San Jose State College Sound Survey of Ventilation System  
Noise in Speech-Drama Building Addition

State of California  
Department of Public Works  
Division of Highways  
Materials and Research Department  
November 1961

SAN JOSE STATE COLLEGE  
SOUND SURVEY OF VENTILATION SYSTEM NOISE  
IN SPEECH-DRAMA BUILDING ADDITION

Figure 1

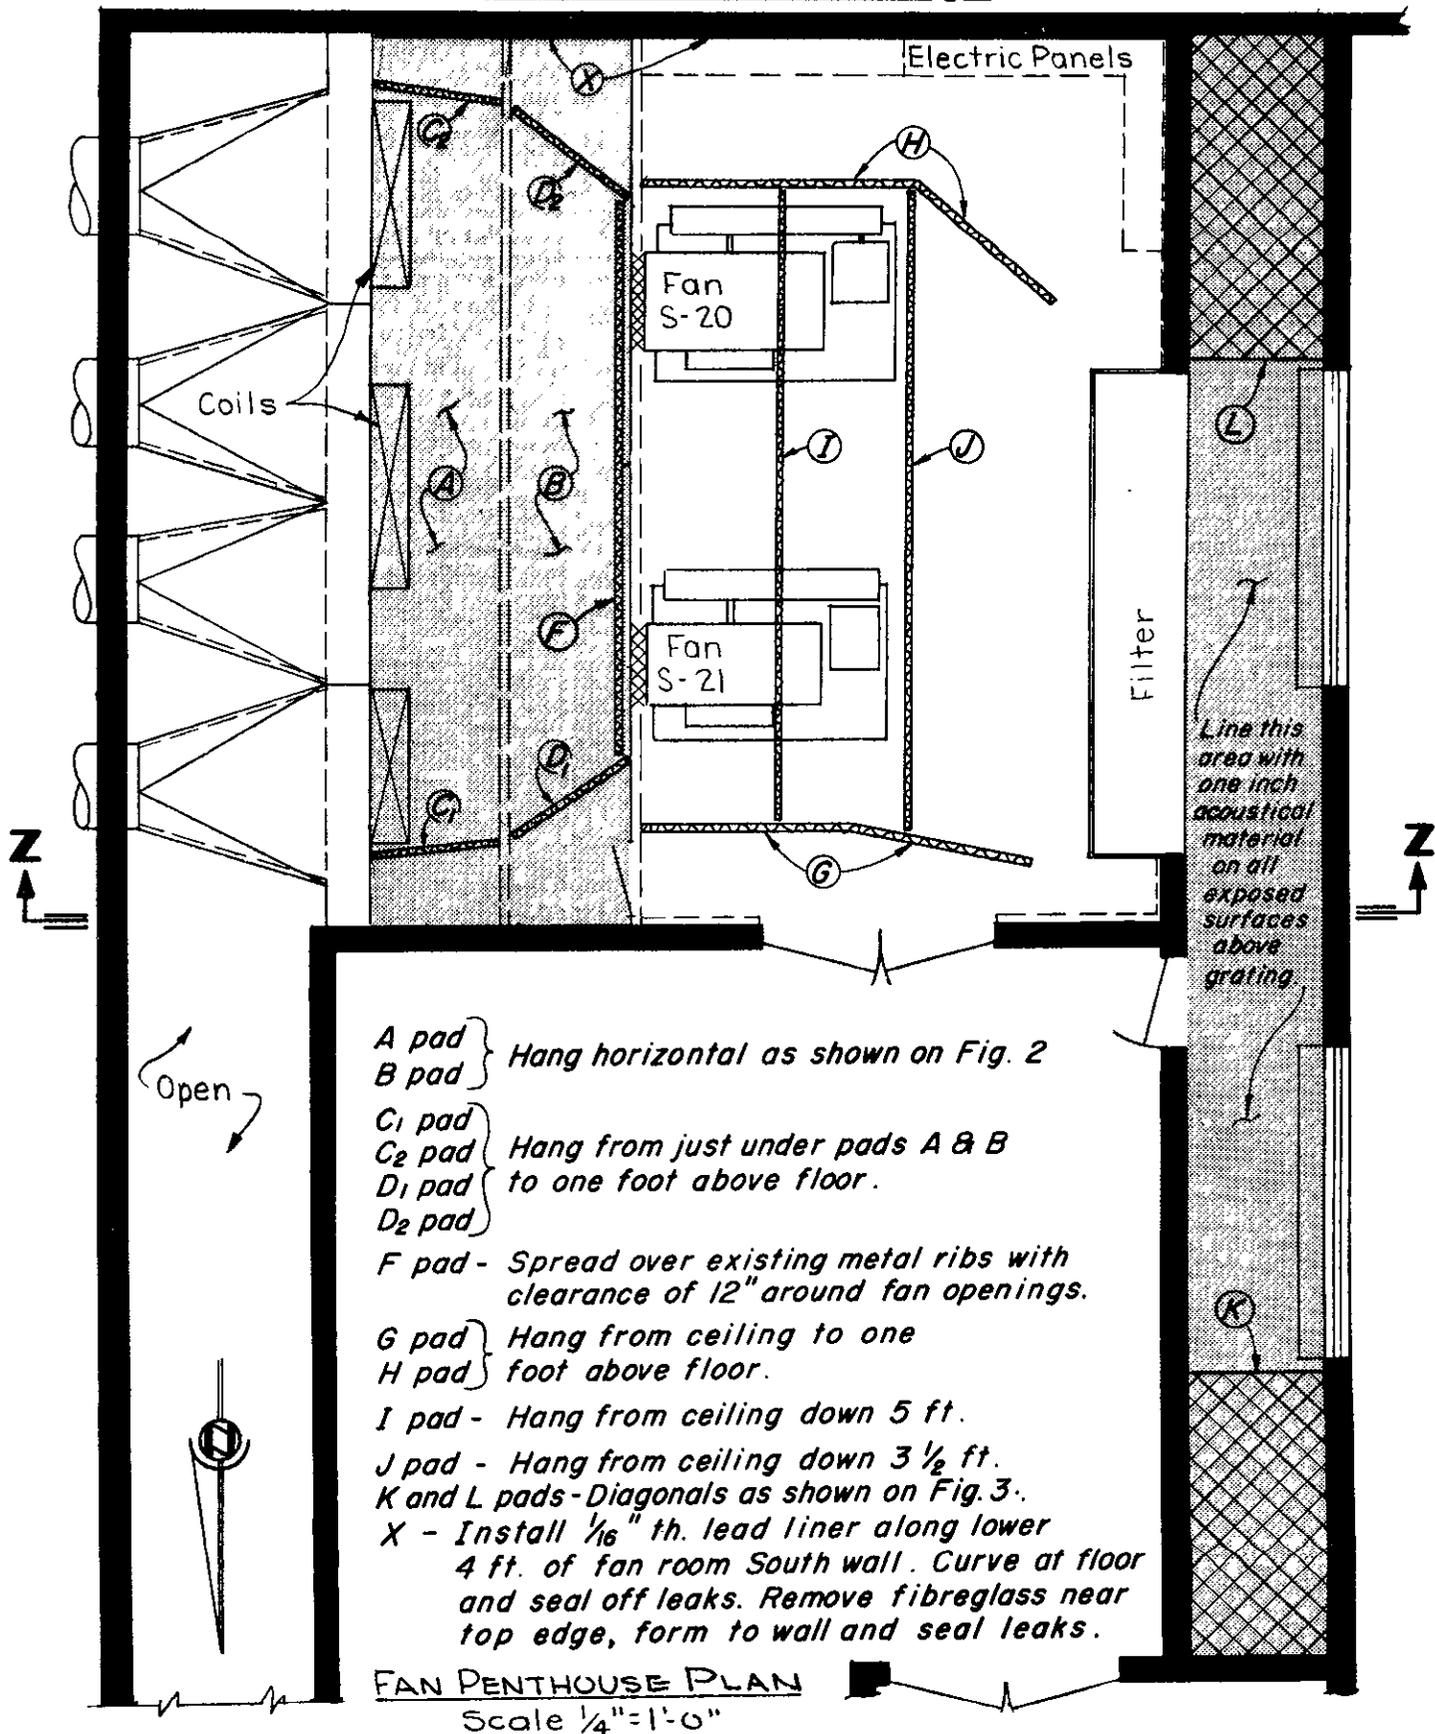
Pads C1 and D1 (in Figures 1 and 2) should be wide enough so that they may be tied together where they meet at the dividing grille so as to minimize the air gap at this junction. The same comment applies to pads C2 and D2.

The diagonal pads K and L, in the return air shaft (Figures 1 and 3), should be mounted with their edges snugly against the walls to minimize air gaps at all pad edge and wall junctions.

The lead (metal) liner X along the lower south side of the fan room (Figure 1) reduces noise penetration into the return air space above the rooms.

**Section Z - Z**  
 Scale 1/4" = 1'-0"

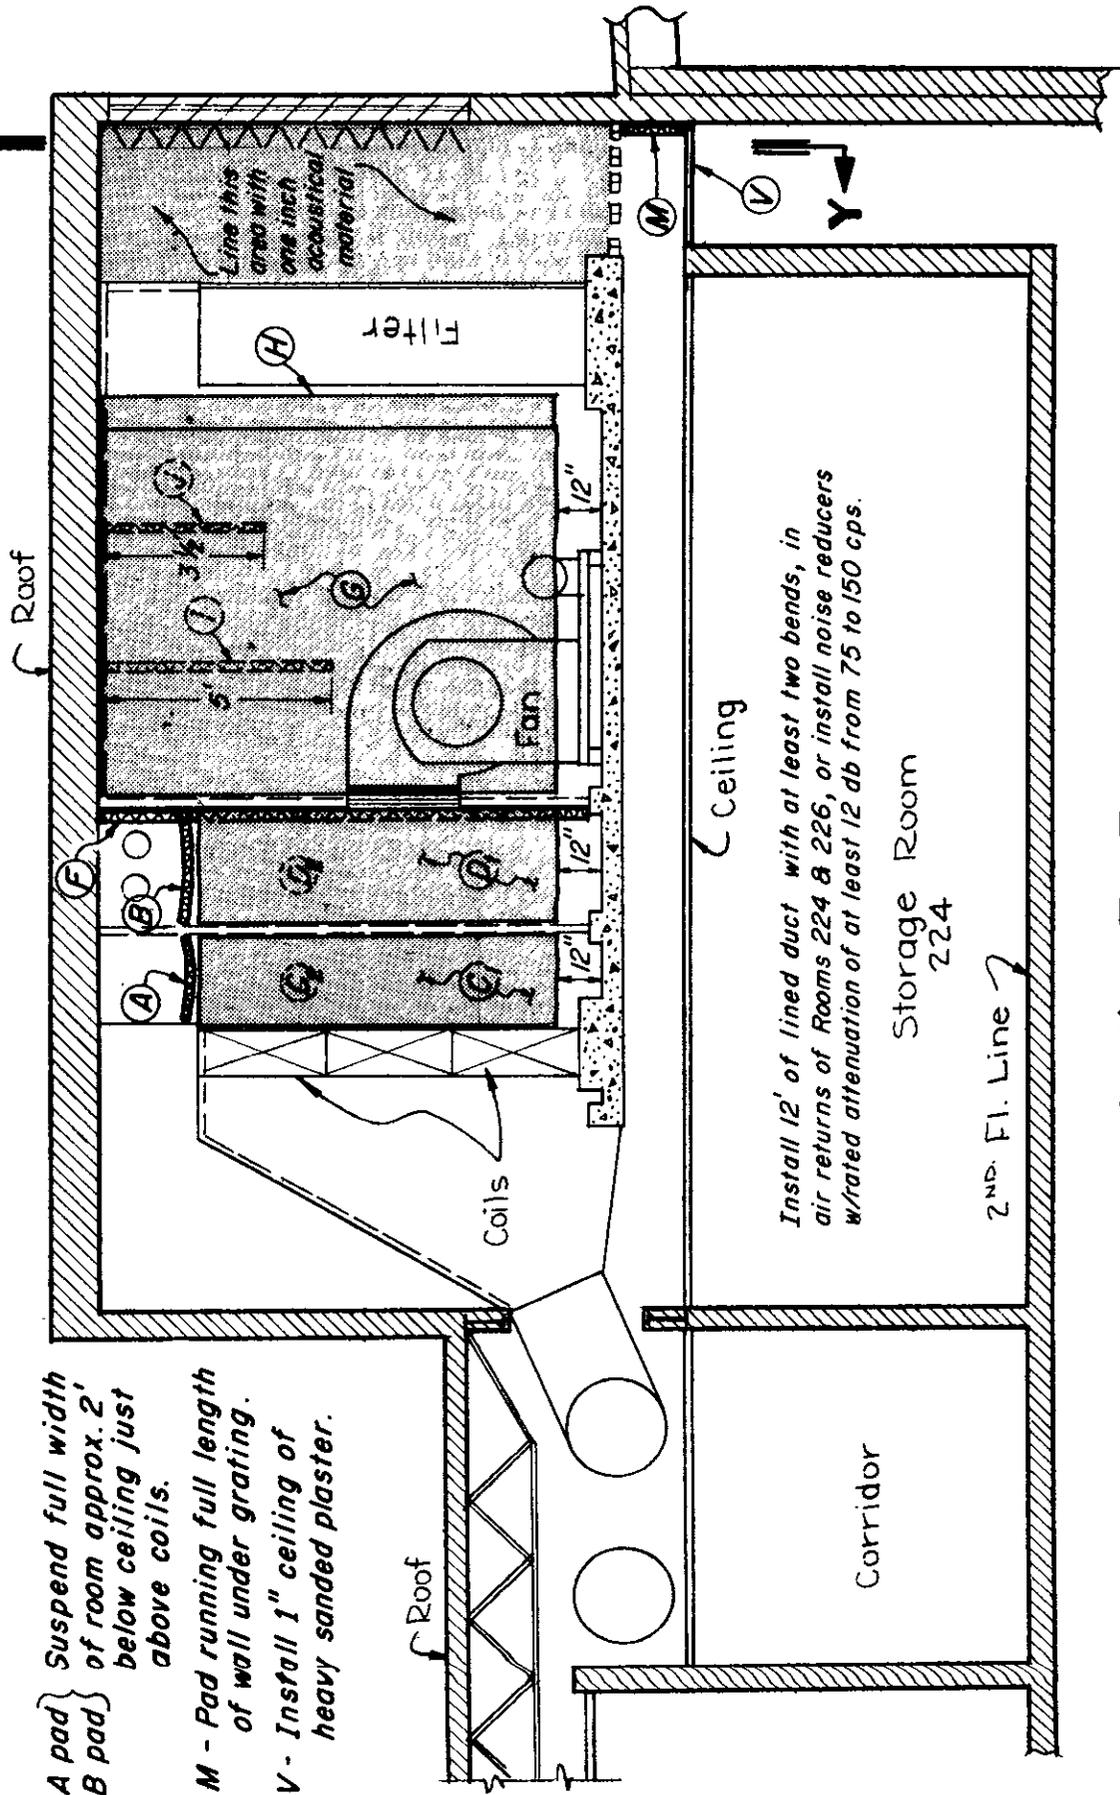
Ceiling V (Figure 2) should be built as a standard ceiling to seal off the unused portion of the return air shaft and reduce noise penetration to Rooms 224 and 226.

Instructions on Figure 2 recommend means for reducing noise penetration via the return air openings in Rooms 224 and 226.

- A pad } Suspend full width
- B pad } of room approx. 2'
- } below ceiling just
- } above coils.
- M - Pad running full length
- } of wall under grating.
- V - Install 1" ceiling of
- } heavy sanded plaster.

## ACOUSTICAL PAD CONSTRUCTION (Typ. const. of pads lettered A thru. M)

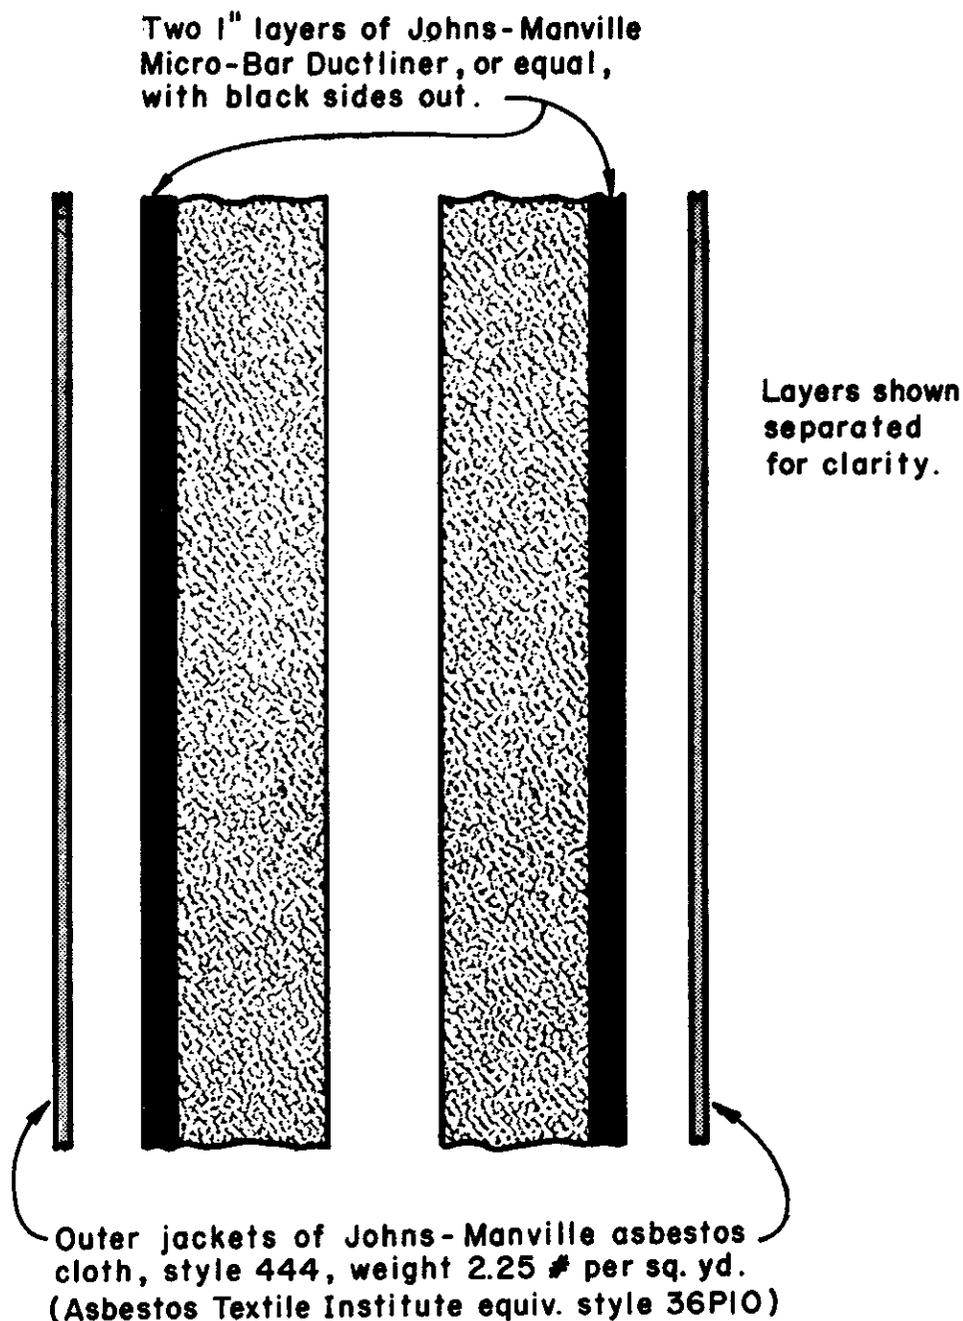
Recommended acoustical treatment and modifications are shown on Figures 1, 2, and 3. All acoustical pads are of the type shown on Figure 4. The materials recommended and method of fabrication are described.

Outer sewn edge of pads shall be an overlap of the asbestos material and shall have metal ferrules every 12 inches (or as desired) for mounting.
